MEMORANDUM

Re: CGO Open Pit Continuation SSD-42917792 - Response to RFIs

Please find below responses to the requests for information in relation to the Cowal Gold Operations (CGO) Open Pit Continuation Project (SSD-42917792) (the Project) including:

Figure 1 – LPB construction stages

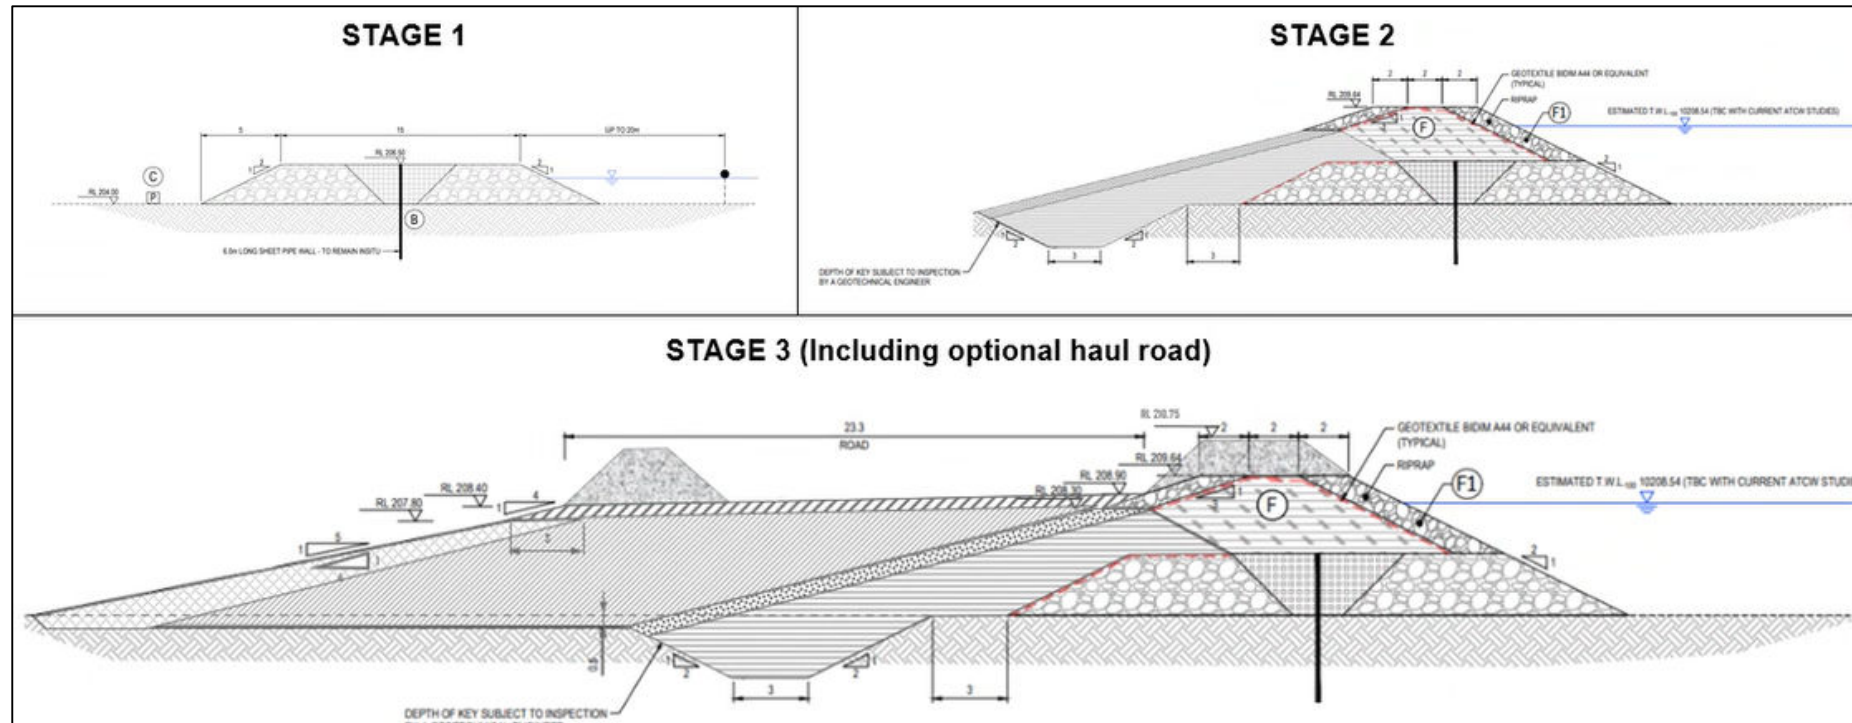
LPB Phased Construction:

The LPB will be built in four stages as summarised below and illustrated in **Figure 1**.

- **STAGE 1:** Construction of a rock groin up to an indicative height of ~ 206.5 mAHD, this will consist of a central finger of engineered rock so that sheet piles can be installed through the groin. The sheet piles are subject to the height of the Lake at time of execution, but currently estimated to be approximately ~6 m in length and will create hydraulic separation between the new mining area and the lake water. This stage is a function of the wet build method that has been proposed and will be subject to change pending the lake levels at the time of construction, changes during this stage will not impact the ultimate height of the LPB.

- **STAGE 2 – Engineered Bund:** The engineered bund will be built to 209.64 mAHD this will consist of excavating a key into the existing lakebed to create a lock for the lake protection then building the LPB to height using compacted clays to ensure a good seal with the surficial lake materials. The clay will be built up on the internal edge of the rock groin before the final profile of the LPB is raised to final design height. The sheet piles will be left in place and while they provide a barrier against the lake the clay core of the LPB will on its own will provide an impermeable barrier against rising lake waters.

The engineered LPB structure will be rock armoured with rip rap to ensure the integrity of the engineered structure is maintained against erosion and surface operations.

- **STAGE 3 – Optional haul road:** A haul road may be constructed on the inside edge of the LPB subject to the operational requirements. This will be constructed by using run of mine oxide material with a rock cap to provide a suitable running surface for the road. This will be sheeted with appropriate geotextile and road base. Exposed bund surfaces will in time be sheeted with a soil rock matrix to promote rehabilitation of these surfaces.

- **STAGE 4 – PMF and Final Landform:** On the back of the Douglas Partners Geotechnical review and the recommendation that the closure strategy should employ a height more closely aligned with the PMF (210.90mAHD). Design of this has yet to be finalised but will be included as a part of the final landform in the Rehabilitation Management Plan. CGO is proposing that the haul road be relocated adjacent to the pit voids and this footprint be used to elevate the LPB. Preliminary designs show that this could be achieved within the existing LPB design footprint. Northern access and southern interaction with lake foreshore will prevent PMF height being achieved for the whole LPB during operations however, schedule logistics suggest that PMF levels for a majority of the LPB could be achieved within 2 years of bund construction with the Northern and Southern areas raised during site closure.

Figure 2: Cross Section of existing LPB at CGO

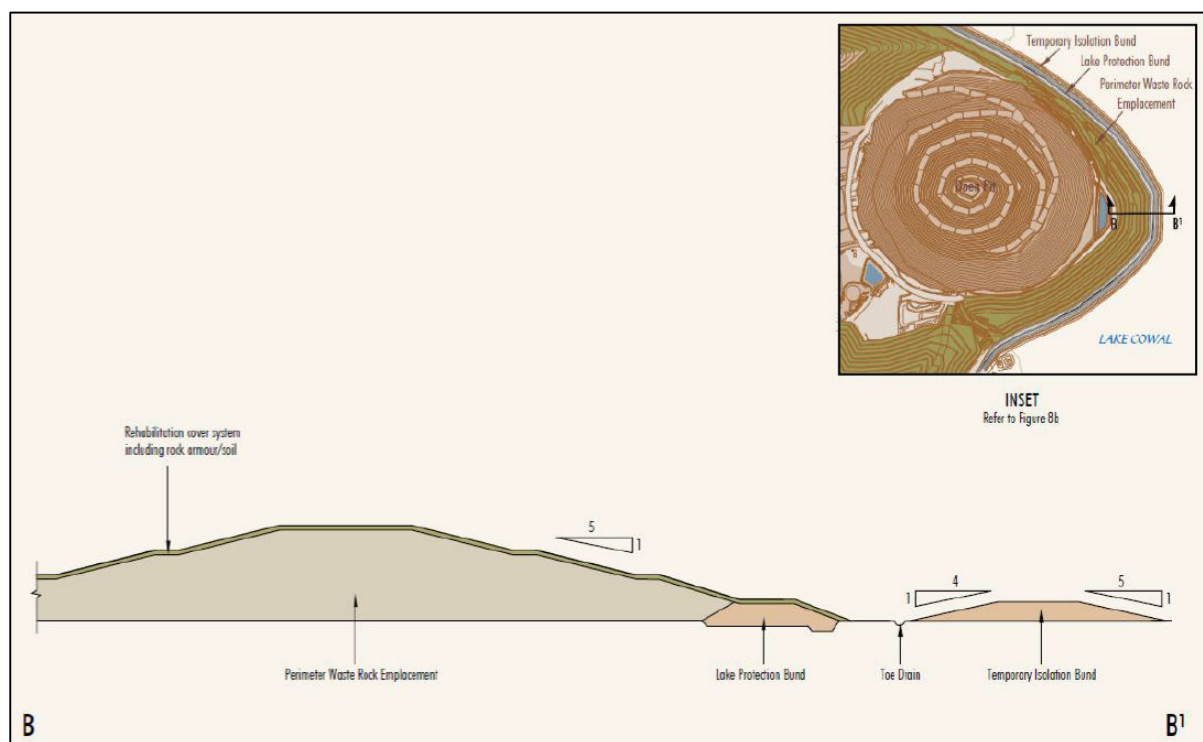
7. How does the proposed LPB design compare to the existing as built LPB, including the approved perimeter waste emplacement integrated into the LPB?

1. The current lake isolation system consists of three elements designed to prevent the inflow of water from lake Cowal into the open pit area, the three elements of the lake isolation system (**Figure 2**) Temporary Isolation Bund (TIB) – At the time of construction the lake was dry enabling a TIB to be constructed using the construction fleet (dozers and scrapers). This bund was built using stripped material from within the footprint of the proposed LPB as well as near surface silty clay from within the contained mining area. As the name suggests it provided temporary isolation for the LPB construction area in the event of rising lake waters. Its construction was rudimentary lacking a key into the lakebed and was a rapid build and lacked engineering control on the compaction of the material. The bund no longer contributes to the function of retaining water.

2. Lake Protection Bund (LPB) this is the engineered bund designed for the purpose of keeping water out of the mining area. It was formed by excavating a key-way and then using silty clays sourced from within the contained mining area. A keyway, excavated during construction of the TIB was backfilled by scrapers in layers and then compacted to an engineered standard. The LPB was built to a height of 208.25mRL 9; this is 1.4m lower than the proposed LPB height and +2m from the eventual PMF height.

3. Perimeter Waste Rock Emplacement (PWRE): upon completion of the LPB the mining area was protected from elevated lake levels and mining could commence. Early stripping from the mining area was hauled to the PWRE and stockpiled, this was constructed in lifts approximating 5.0m in line with construction methods adopted for all site Waste Rock Emplacement (WRE) areas. The material was not compacted other than by the equipment during the construction phase. This component has been removed from the OPC LPB design due to several key drivers:

Figure 3: Post mining drainage system overlayed with landform

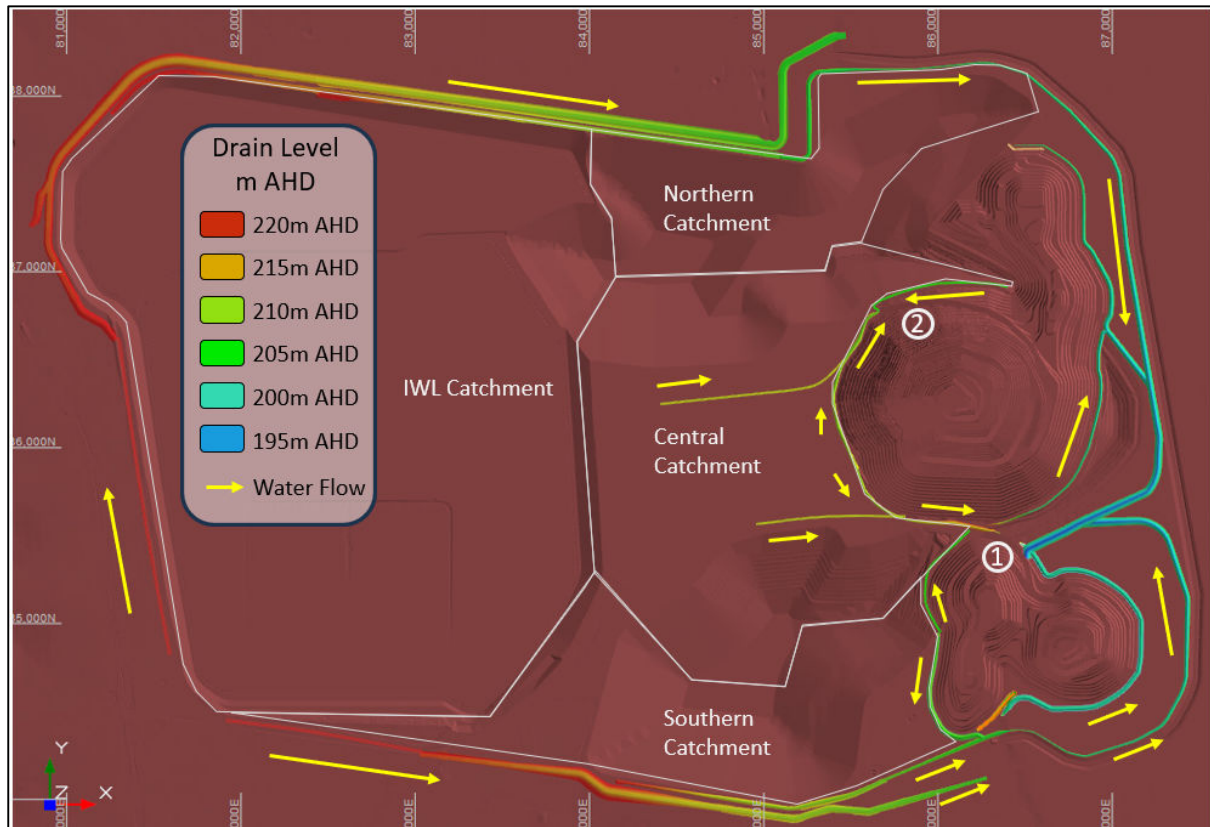
8. Provide a figure showing final conceptual water catchments and drainage, including significant surface water management structures, such as 'drop structure', spillways and drainage channels, demonstrating minimising catchment reporting to the final void.

A conceptual closure strategy (strategy) has been prepared. A key element of the strategy is to manage surface water post mining. The strategy will be subject to change as pit closure landforms are yet to be finalised, however the fundamental drainage strategy will be inherent in further refinements of this landform strategy.

Major water management infrastructure including the Upper Catchment Drainage System (UCDS) and Internal Drainage Catchment System (ICDS) will be left in place post mining with minor updates to remove water storage elements. This is to maintain the separation of water between the CGO mining area and offsite water. Additional drainage structures to prevent water from draining over the crest of all voids are also proposed as a part of this strategy to ensure water is directed towards controlled pit

drainage points. **Figure 4**, provides an overview of the proposed closure water strategy overlayed with the closure landform.

The strategy includes:

- Water naturally flows from west to the east towards Lake Cowal, offsite water flowing from the west will be diverted around the site by the UCDS as per the operational phase of the mine.

- There are four western catchment areas of note that work as a connected, holistic system:
 - **The IWL Catchment:** will be capped and vegetated at closure. A spillway will be maintained as a low point so extreme rain events direct water over a dedicated discharge point to the central catchment and E42 Pit.

- Drainage systems around the pit voids have been designed to eliminate water actively flowing over the pit faces, these systems will evolve from the drainage systems proposed during the active mining phase and at closure will be connected to flow into several dedicated discharge points.
 - Most of the drains will direct water into the ICDS which will divert water to the Eastern side of the site before diverting water back to the E41 ramp system where it will discharge into the void ①.
 - Water from the central catchment will be diverted to both the E42 ① ramp system and the E41 ② ramp system to be collected in the pit voids.

Figure 4: FoS contour Plot for E42 pit wet scenario

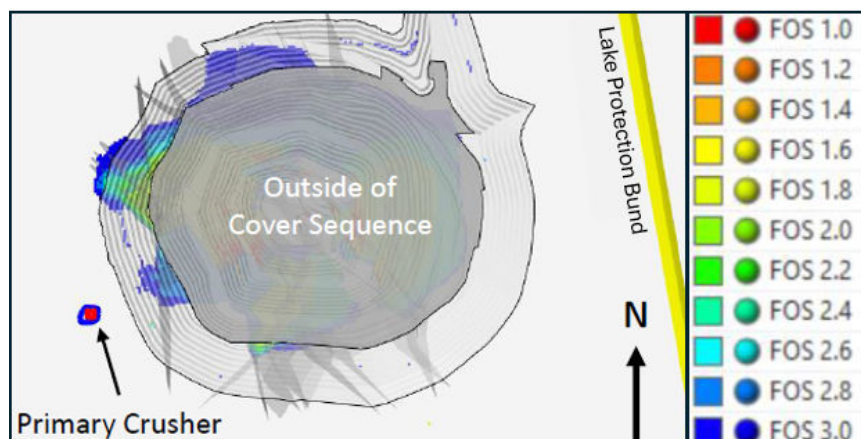
9. For a mining scenario with the greatest open pit extent, demonstrate (including in a final landform plan) that there would be sufficient footprint in the proposed disturbance area to not impact on the final landform LPB (including post mining), assuming a FOS of 1.5 on the eastern pit wall and include sensitivity analysis under different drainage conditions.

Numerical modelling of the E42 pit using SlopeX and FLAC^{3D} software was undertaken for wet (no dewatering bores) and dry scenarios. This work indicated that the eastern wall of the E42 pit is stable and exceeds a FoS of 3.0 contours for which are provided in **Figure 4**.

Figure 6: Minimum distances between pit crest and LPB final landform (pit crest to LPB toe)

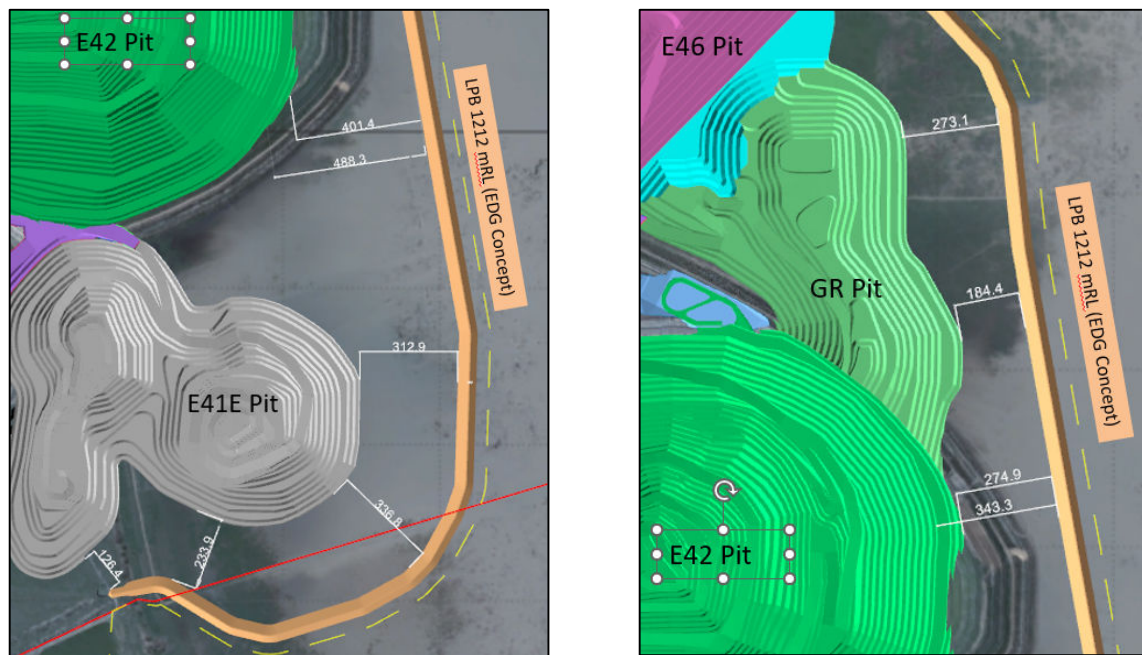
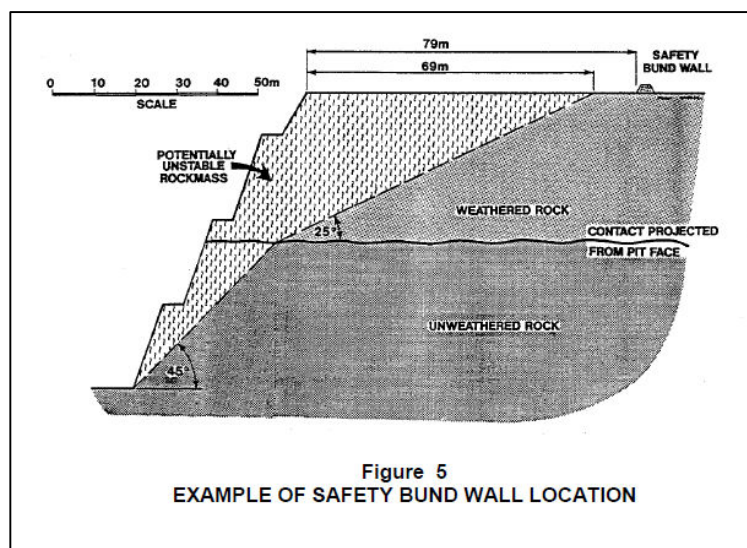
10. What distance / buffer between open cut pit/s and the final LPB design to meet PMF height is available?

The crest to toe distance between the current pit crest and the toe of the LPB design is not constant and the buffer distance between each of the pits varies. The closest crest to LPB toe distance for each of the pits is (see **Figure 6**):

- E41 pit – 126.4m on the Southern extent of the LPB, the Eastern area is over 300m.
- E42 pit – 343.3 metres
- E46 pit – This pit is being backfilled and therefore no assessment was prepared,
- GR pit – 184.0m

Figure 8: Modelled post mining groundwater flux to pit

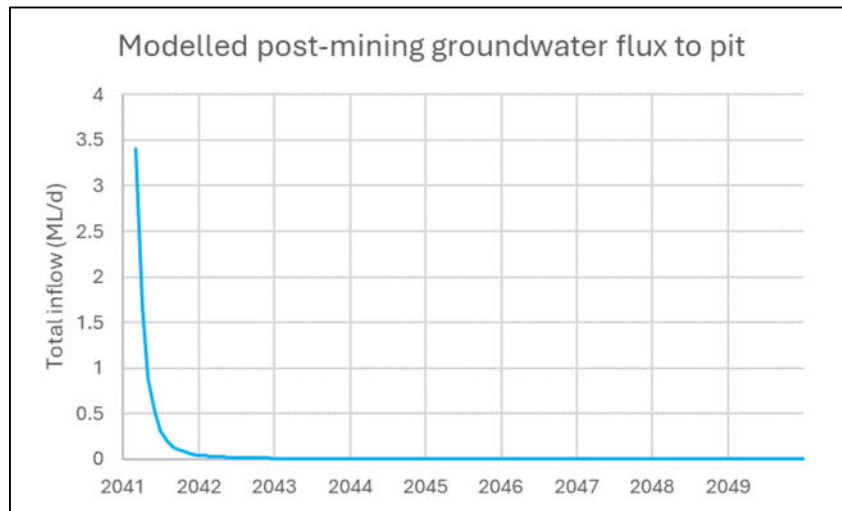
2. Mine inflows – section 6.2 of the Revised Groundwater Impact Assessment indicates groundwater inflows are expected to reduce to less than 0.01 ML/da by the start of 2043. Figure 6.6 does not extend beyond 2040, but inflows in 2040 appear to be around 3.6 ML/day. What is the reason for this steep reduction in inflows? Can you extend this graph out beyond the end of mining?

The data shown in Figure 8 depicts the modelled inflow to the pit post-closure, though without influence of pit lake evaporation or incident rainfall. The modelled inflow reduces as the in-pit water level returns towards pre-mining levels, due to lowering of the hydraulic gradient between the aquifer and the pit. This data was used towards the water balance modelling, where a function of flux against pit lake water level was used in predicting long-term in-pit water levels.

Model hydrographs do not equilibrate by the end of the 100-year post-mining period. An additional long-term run of the base realisation model predicts equilibration to be reached between 10,000 and 100,000 years following the cessation of mining, owing to the very low hydraulic conductivity of some hydrostratigraphic units. The footprint of the 2 m modelled drawdown contour increases by up to 7 km in the Upper Cowra and Lachlan HSUs. For this reason, analysis in the Groundwater Impact Assessment is not considered to be feasible.

Figure 9: Long-term measured water levels in Lake Cowal

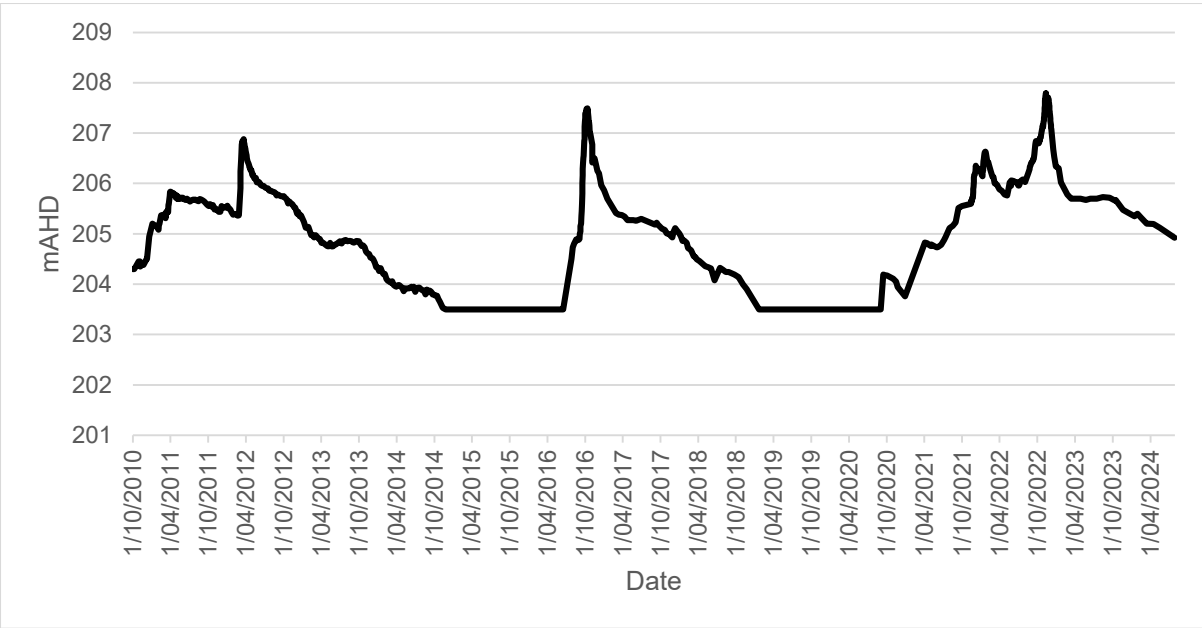
How full (%) is Lake Cowal at the moment?

Measured water levels in Lake Cowal since 2010 are presented in **Figure 9**. The highest recorded water level in Lake Cowal was 207.8 mAHD recorded in November 2022. Water levels, as at the end of July 2024 were at 204.92 mAHD which represents about 98% of the highest recorded water level. PMF modelling indicates water levels may reach 210.54 mAHD. Current water levels represent about 97% of the PMF levels within the Lake.
